# Access Compliance Report

## Public Rights-of-Way

Intersection ID: 16696	Main Street: COUNTRY_OAKS_RD	Cross Street: E W T HARRIS BV	Location: SE
ADA ID: EE39FAC2ACA6	Ramp Type: PerpDiag	Initial Pass/Fail: Fail	Overall Compliance: No
Severity Score: 26.25			
Codes/Mitigation Info/Possible Solution		Field Measurements/Component Compliance

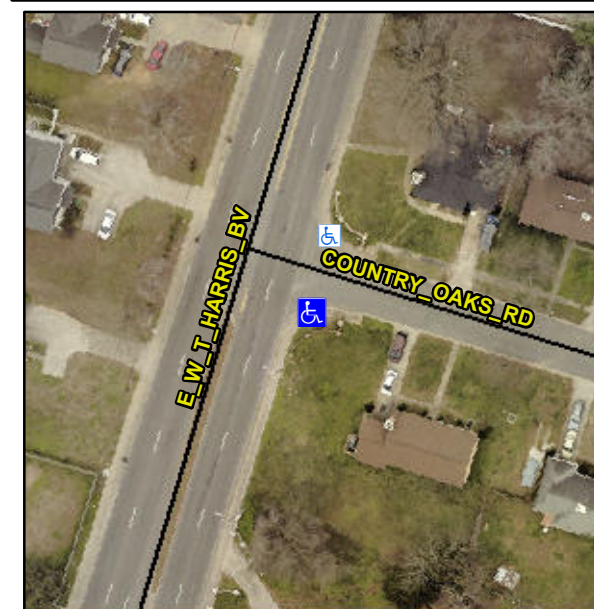
**Not Found, R304.2.2, R304.5.3**

Compliance	Description	Data	Compliance	Description	Data
N/A	Ramp Length (in)	58.0	No	Ramp Slope (%)	12.1
Yes	Ramp Width (in)	48.0	No	Ramp XSlope (%)	3.8
N/A	Flare Type LT	N/A	N/A	Flare Type RT	N/A
N/A	Flare Slope LT (%)	N/A	N/A	Flare Slope RT (%)	N/A
N/A	Flare Traversable LT?	N/A	N/A	Flare Traversable RT?	N/A
N/A	Landing Length (in)	N/A	N/A	DWS Provided?	N/A
N/A	Landing Width (in)	N/A	N/A	DWS Contrast?	N/A
N/A	Landing Slope (%)	N/A	N/A	DWS Length (in)	N/A
N/A	Landing X Slope (%)	N/A	N/A	DWS Full Width?	N/A
N/A	Landing Curb? (Y/N)	N/A	N/A	DWS Offset (in)	N/A
N/A	Shared Landing?	N/A			
N/A	Gutter Ponding?	N/A	N/A	Gutter Slope (%)	N/A
N/A	Gutter Lip Ht (in)	N/A	N/A	Gutter X Slope (%)	N/A
N/A	Painted X Walk1?	No	N/A	Painted X Walk2?	No
	X Walk 1 Direction	To NE		X Walk 2 Direction	To NW
N/A	X Walk 1 Width (in)	N/A	N/A	X Walk 2 Width (in)	N/A
	X Walk 1 Slope (%)	4.7		X Walk 2 Slope (%)	3.2
	X Walk 1 X Slope (%)	3.8		X Walk 2 X Slope (%)	1.8

**Remove & Replace Curb Ramp With Two New Directional Ramps or Equivalent.**
